Product Change Notice

Sub: Packaging changes for FCSL110 and FCSL150 series. Effective Immediately

Old:

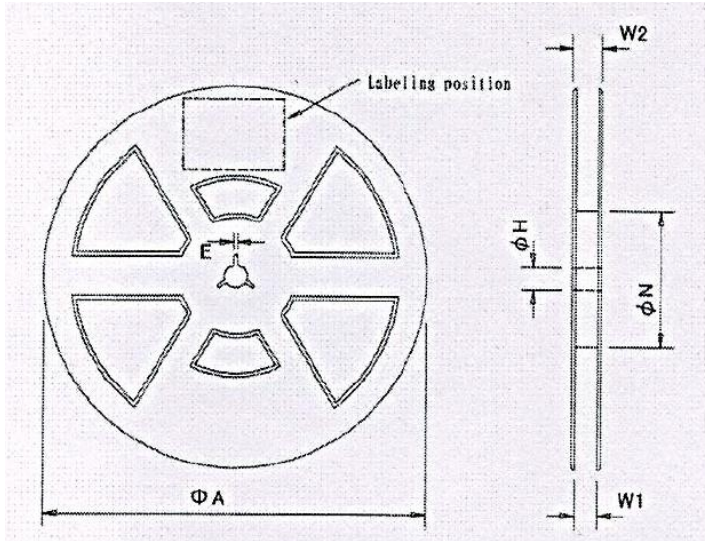
Ohmite announces dimensional changes to the reels of FCSL110 and FCSL150 series parts. The "A" dimension of the current reels are 330mm +/- 2mm. This dimension will change to 180mm +/- 2mm. The "N" dimension will change from 100mm +/- 1mm to 21mm +/- 0.8mm. Existing stock of the old reel sizes will be shipped until stock is exhausted. Parts are stocked by value and wattage. There may be instances when two part numbers may arrive with two reel sizes due to stock demands. Old and New reel dimensions are listed below for reference.

A	12.992 (330±2.0)
H	0.512 (13±0.2)
E	0.079 (2.0 ±0.5)
N	3.937 (100±1.0)
W ₁	1.000 (25.4 ±1.0)
W ₂	1.157 (29.4 ±1.0)

Dimensions (mm)
ΦA	180±2.0
ΦH	13±0.2
E	2.0±0.5
ΦN	21±0.8
W1	25.4±1.0
W2	29.4±1.0
